ADDENDUM NO. 03

Project: Wastewater Treatment Facility Improvements
Walnut Ridge, Arkansas

The Contract Documents dated February 3, 2021, are hereby amended as follows:

Wastewater Treatment Facility Improvements

DESIGNED: CAJ	JOB NO. 1618	DATE MAR, 2021	ADD. NO. 3
DRAFTED: SBM	SCALE:		REF SHEET
CHECKED: CAJ	NOT TO SCALE		C-14

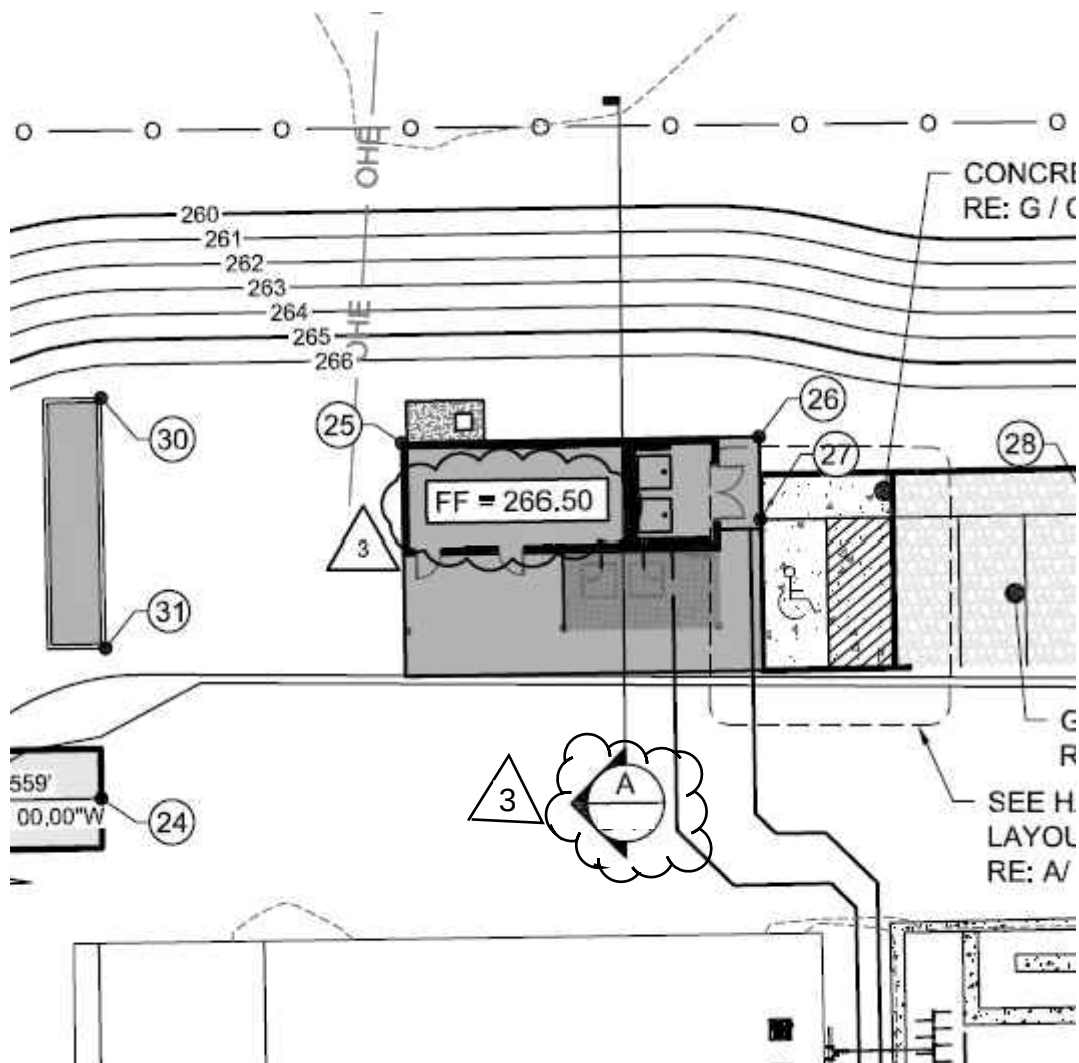
8. Drawing C-14 – Grading and Paving Plan:

- a. Modify this drawing as shown on the Addendum No. 3 – Grading and Paving Plan, attached hereto.

HEADWORKS,
SBR 01, SBR 02, & SBR 03
INSTALL RAMMED AGGREGATE PEIR
FOUNDATION SYSTEM, LOCATION
SIZE & DEPTH DETERMINED
BY PIER DESIGNER IN ACCORDANCE
WITH SECTION 316613 (TYP)
RE: ADD NO 3 / S-8 & ADD NO 3 / S-17

CRIST ENGINEERS, INC. CONSULTING ENGINEERS LITTLE ROCK, ARKANSAS	
WALNUT RIDGE, ARKANSAS CITY WATER WORKS WWTF IMPROVEMENTS	
BUILDING SECTIONS	
DESIGNED: CAJ	JOB NO: 1618 DATE: MAR 2021 ADD NO. 3
DRAFTED: SBM	SCALE: NOT TO SCALE REF. SHEET A-201
CHECKED: CAJ

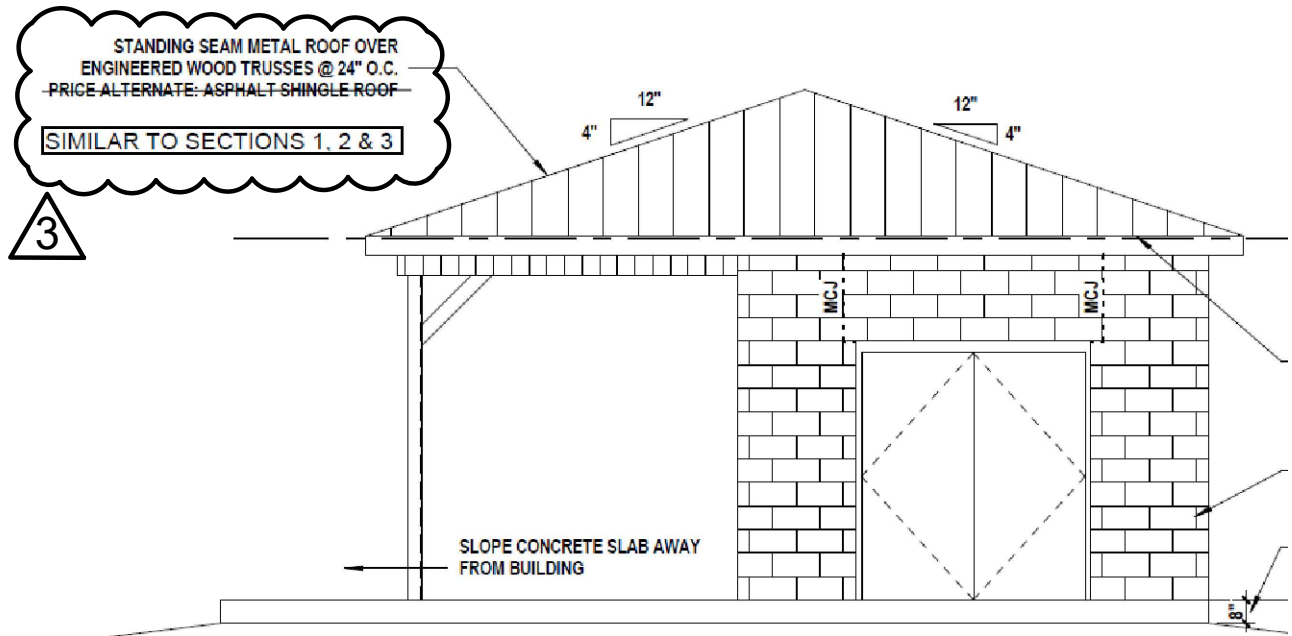
9. Drawing A-201 – Building Sections:

- a. Modify this drawing as shown on the Addendum No. 3 – Building Sections, attached hereto.

HEADWORKS
RAMMED AGGREGATE PIER FOUNDATION

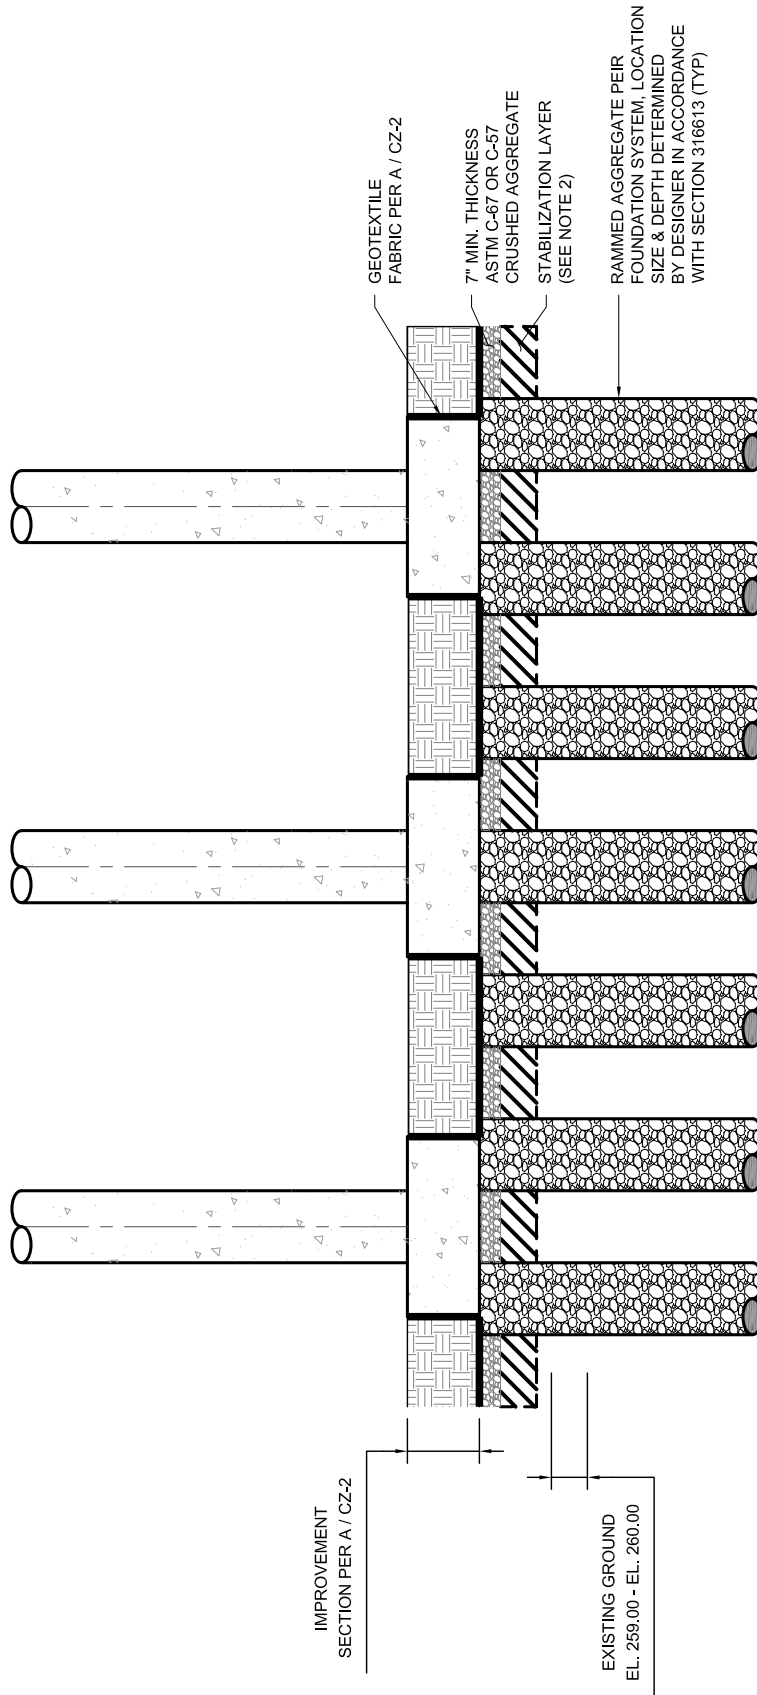
10. Drawing S-8 – Headworks – Structural General Arrangement:

- a. Modify this drawing as shown on the Addendum No. 3 – Headworks – Structural General Arrangement, attached hereto.

1. STRUCTURAL DIMS. & NOTES REMOVED FOR CLARITY.
2. CONTRACTOR SHALL COORDINATE WITH RAMMED AGGREGATE PIER FOUNDATION SYSTEM DESIGNER & CERTIFIED INSTALLER TO PROVIDE ADEQUATE STABILIZATION FOR THE INSTALLATION OF GEOPIERS IN ACCORDANCE WITH SECTION 316613.
3. REMOVAL OF UNSUITABLE ORGANICS UNDER THE STRUCTURAL SLAB SHALL BE SUBSIDIARY TO THE INSTALLATION OF THE STABILIZATION LAYER FOR THE PIER SYSTEM.

SBR 01, SBR 02, SBR 03
RAMMED AGGREGATE PIER FOUNDATION

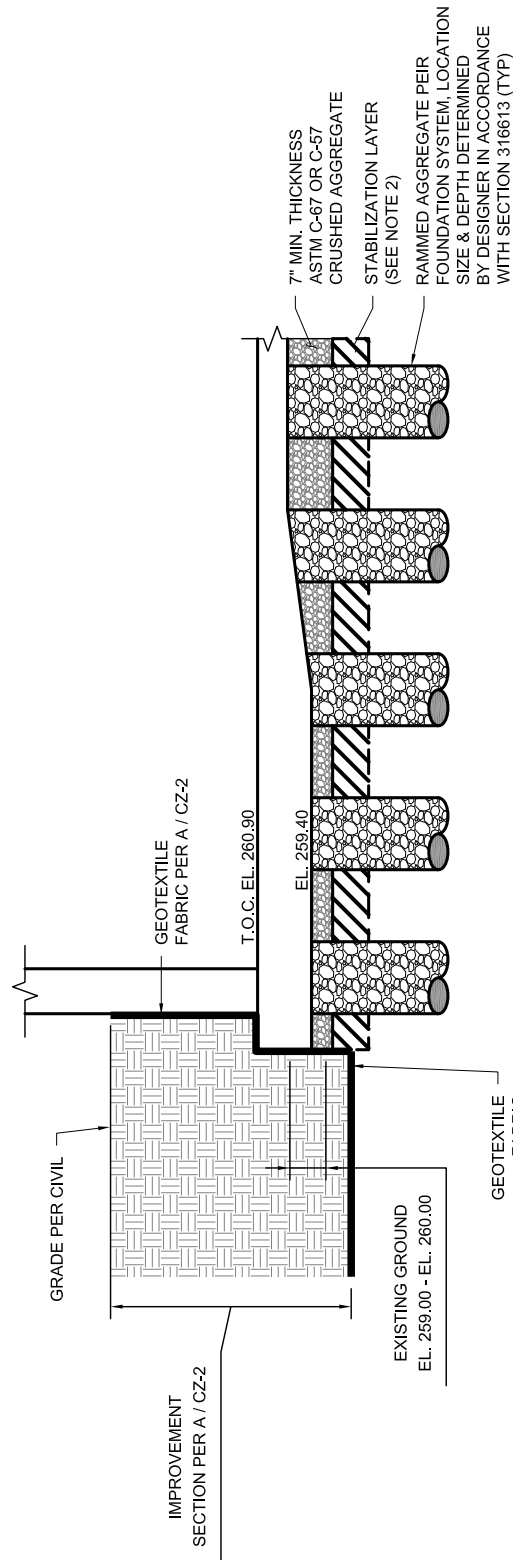
11. Drawing S-17 – SBR Section & Details:

- a. Modify this drawing as shown on the Addendum No. 3 – SBR Section & Details, attached hereto.

1. STRUCTURAL DIMS. & NOTES REMOVED FOR CLARITY.
2. CONTRACTOR SHALL COORDINATE WITH RAMMED AGGREGATE PIER FOUNDATION SYSTEM DESIGNER & CERTIFIED INSTALLER TO PROVIDE ADEQUATE STABILIZATION FOR THE INSTALLATION OF GEOPIERS IN ACCORDANCE WITH SECTION 316613.
3. REMOVAL OF UNSUITABLE ORGANICS UNDER THE STRUCTURAL SLAB SHALL BE SUBSIDIARY TO THE INSTALLATION OF THE STABILIZATION LAYER FOR THE PIER SYSTEM.

DESIGNED: CAJ	JOB NO: 1618	DATE: MAR 2021	ADD NO. 3
DRAFTED: SBM	SCALE: NOT TO SCALE	REF. SHEET SZ-5	
CHECKED: CAJ

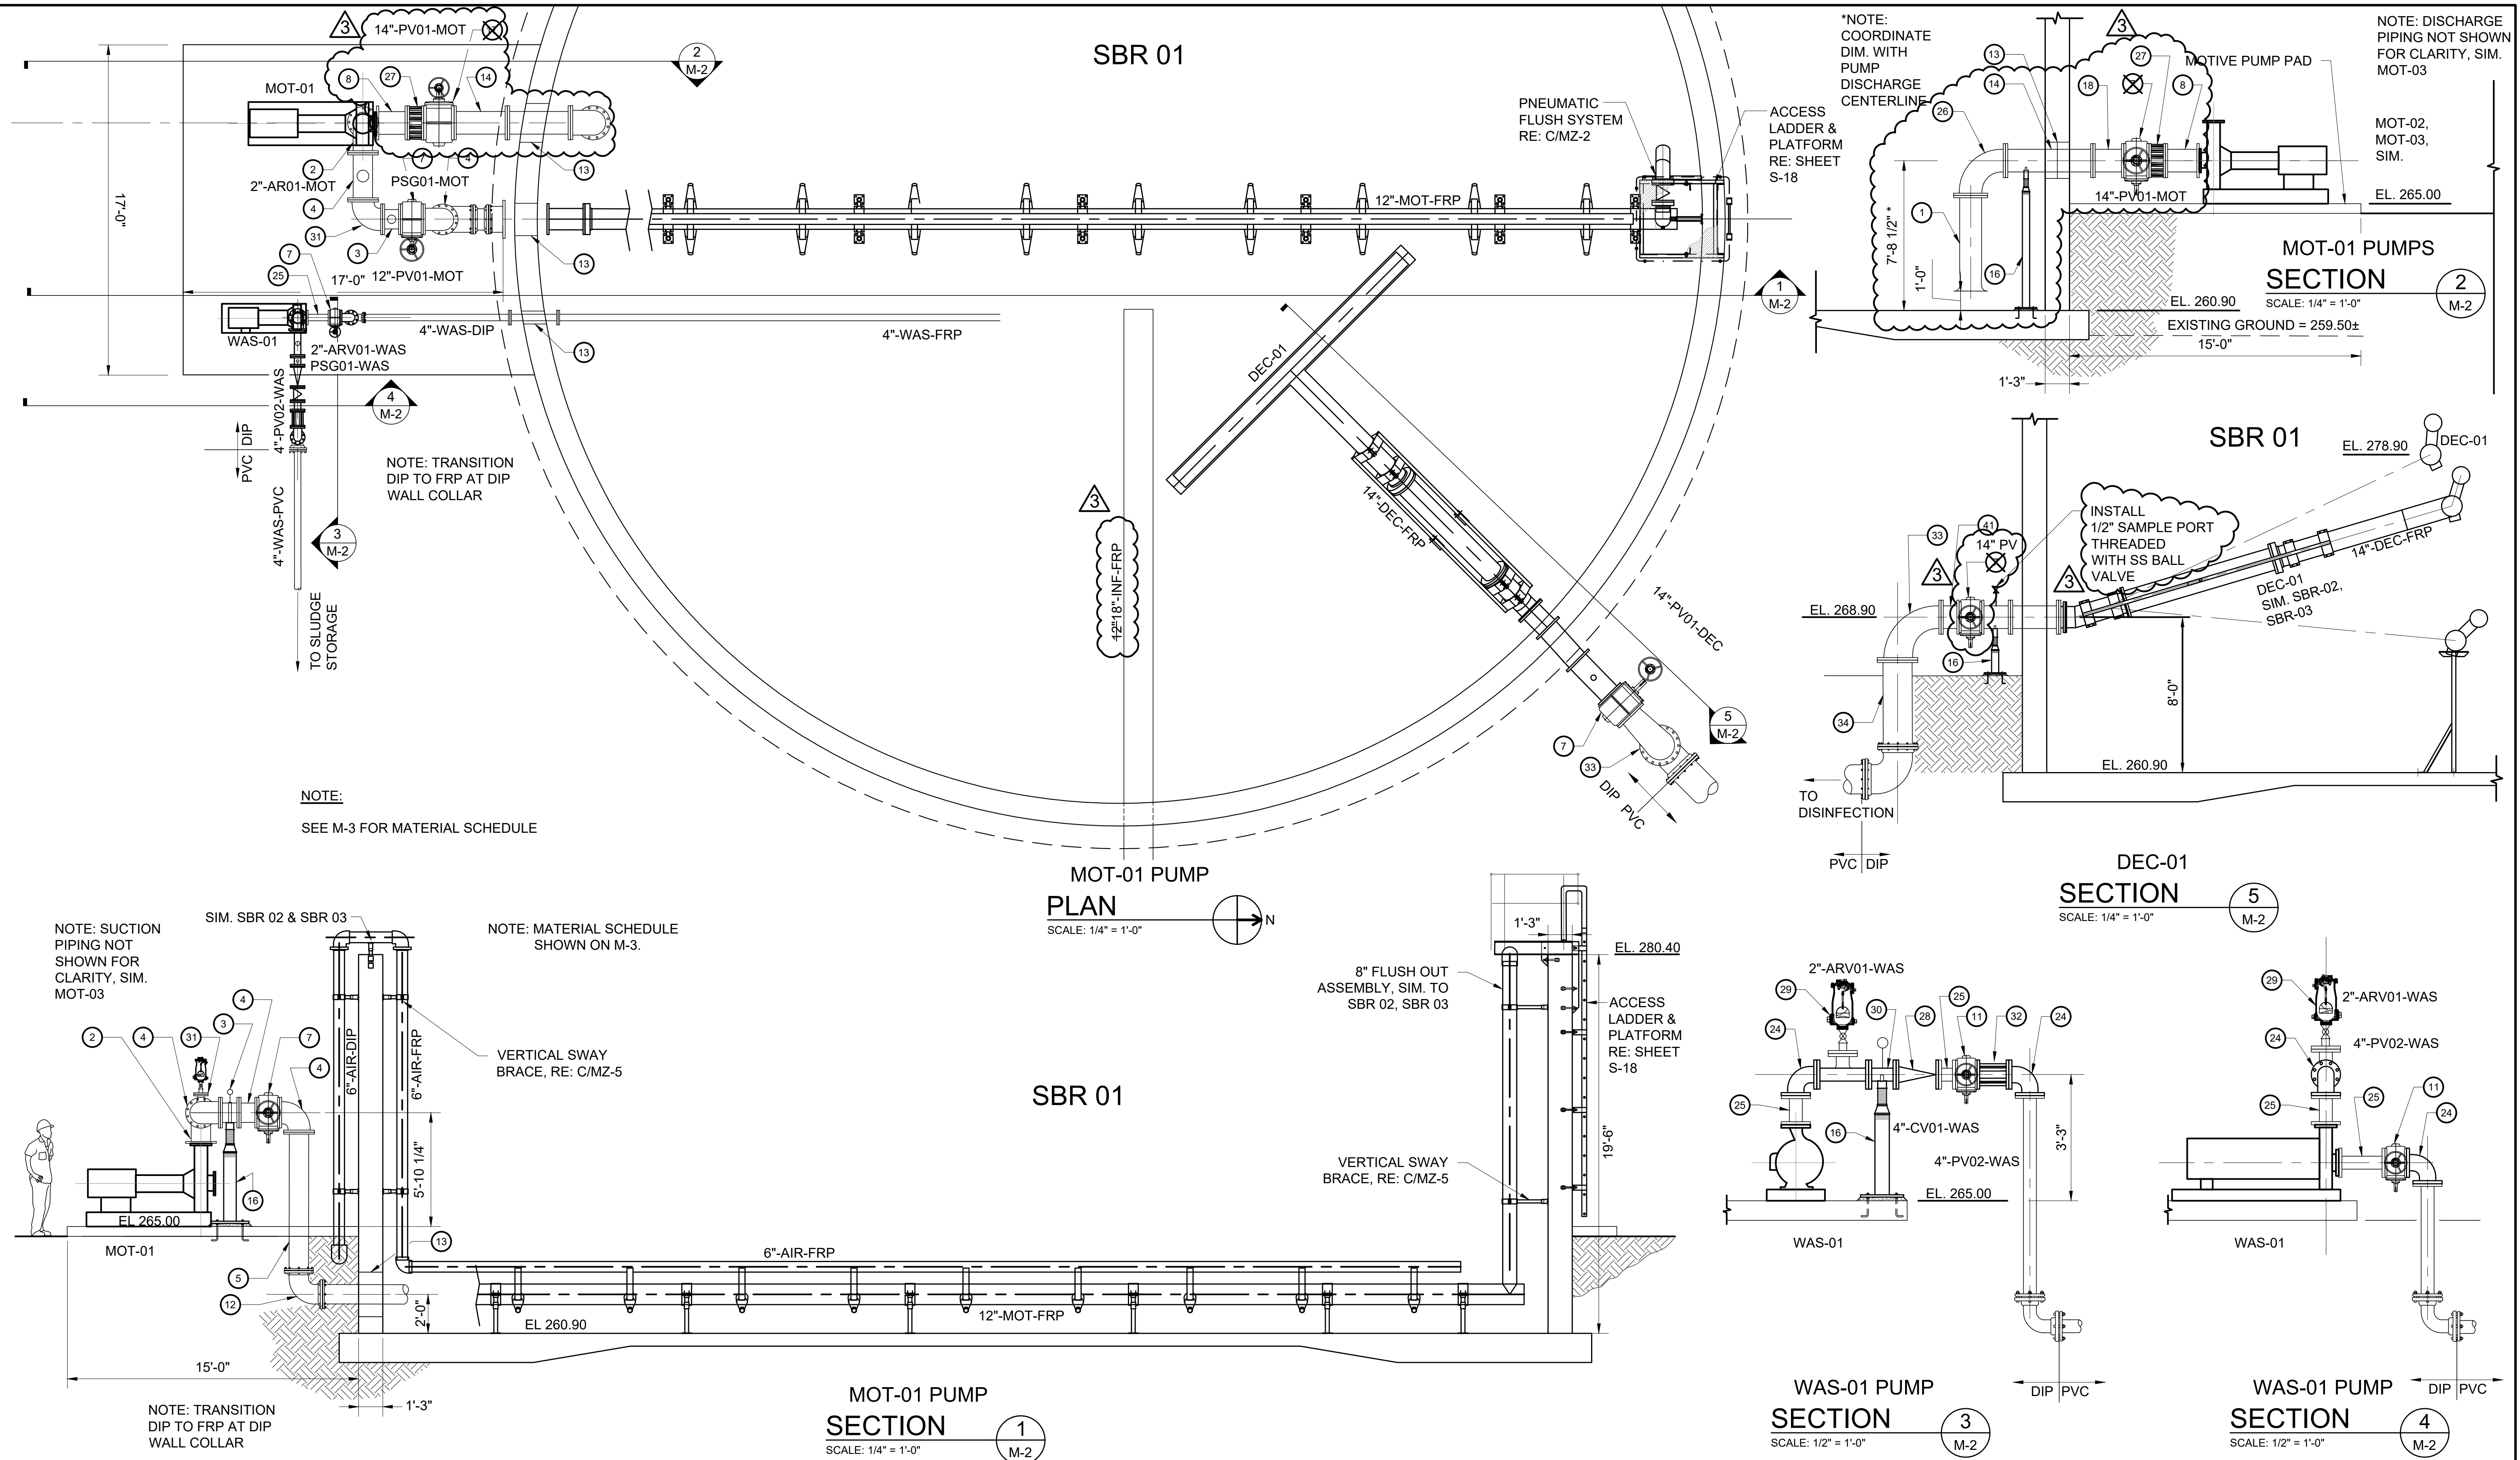
12. Drawing SZ-5 – Structural Details V:

- a. Modify this drawing as shown on the Addendum No. 3 – Structural Details V, attached hereto.

** NOTE: WHERE LENGTH OR "L" IS GREATER THAN 15'-0", PROVIDE #6 BARS @ 10" LONGITUDIAL BARS.
